Submission re 37 Archer St SSD- 73277714

My submission is around traffic and active transport matters, and I refer to the proponent's Transport and Parking Impact Assessment (TPIA) (May 1995).

The proposal is for a mixed use building accommodating a food and beverage retail outlet, commercial property, and 125 apartments.

Figure12: Managing Congestion

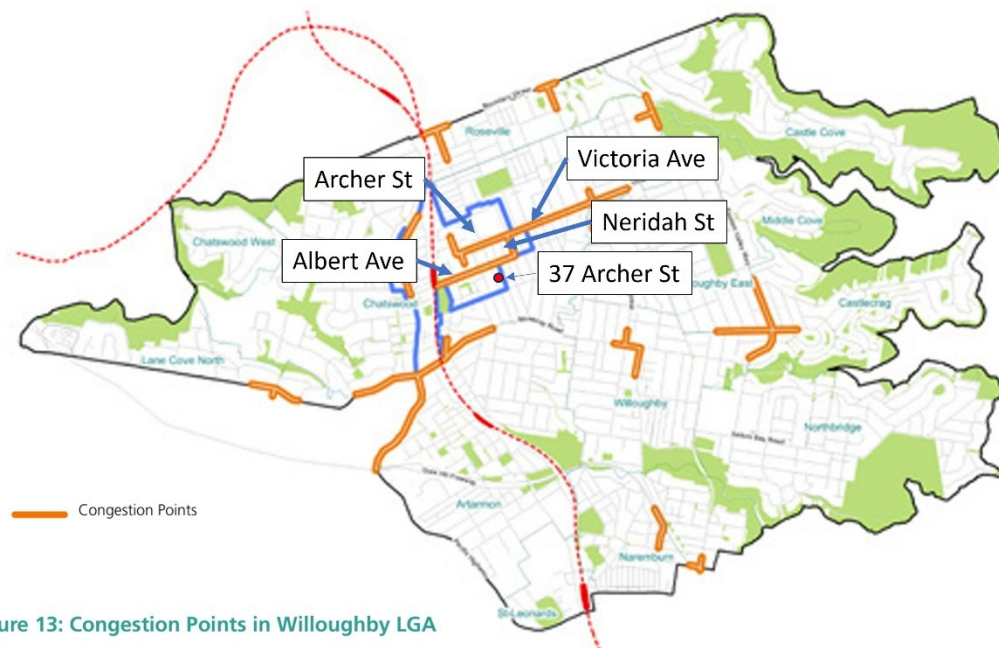
The above observation is supported by Council's WILLOUGHBY INTEGRATED TRANSPORT STRATEGY 2036 (Aug 2020) which notes Albert Ave as a congested street, as per annotated figure below:

Figure 3: Number of Vehicles – Entry Hourly Profile (any duration)

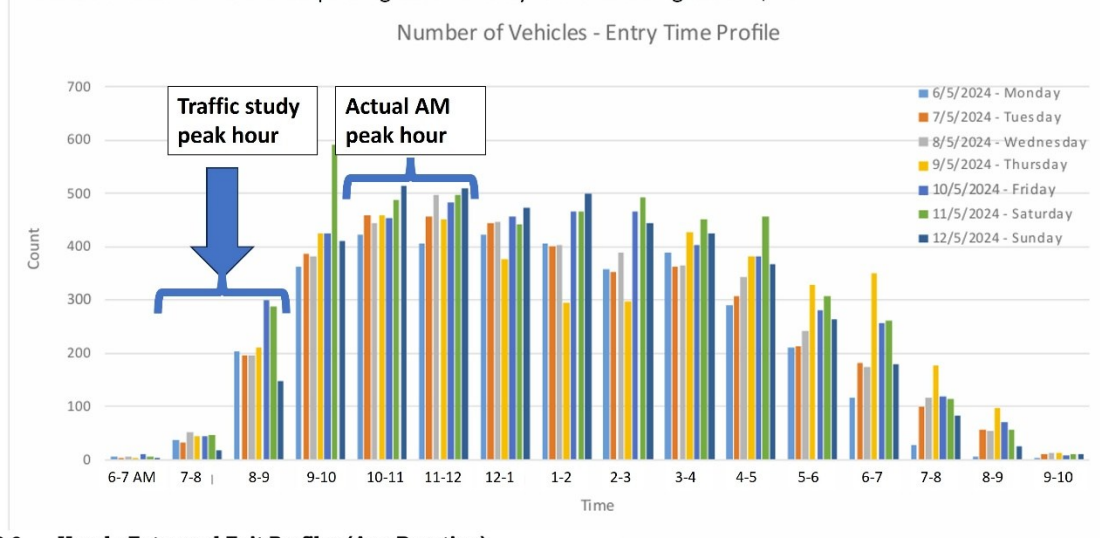
The proponent's traffic observations were on week days, 7-9 AM and 4-6 PM. Chatswood is a retail centre with dominantly retail traffic, and many of the major retailers do not open until after 9 AM. Chatswood Chase advertises its weekday opening hours as 9:30 AM to 5:30 AM. Chatswood Chase vehicle entry data confirms the peak time for retail vehicle traffic is 10 AM to 12 AM (figure below). Albert Ave is only lightly used in the hours 7-9 AM. The proponent's traffic study thus does not capture a period of very significant local traffic. The Chatswood Chase traffic data also shows very significant traffic on Saturdays. Weekend traffic was not included in the proponent's traffic study.

It is apparent that the TPIA does not correctly represent the traffic conditions, present or future, in the vicinity of the proposed development site. Better accuracy is required, and more bike spaces, consistent with a desire to encourage Green Travel.
